Assembly Location Change Plus Mold Compound and Silver Epoxy Change for Platform Flash VOG20 Packages

XCN16001 February 22, 2016

Product Change Notice

Figure 1: Top Mark Detail

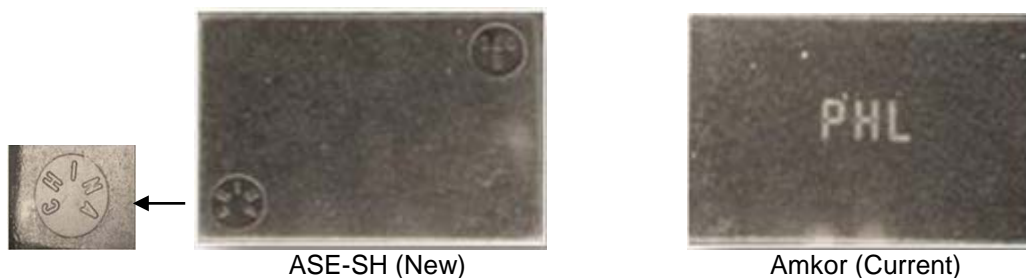
Country of origin will be changed from PHL to CHINA under package bottom by molding ejector pin (refer to [Figure 2](#)), and pin# 1 indicator change from molding ejector to laser mark (refer to [Figure 1](#)) on package in new assembly ASE-SH. The Top marking and Country of Origin detail for method of Identification is in [Table 2](#).
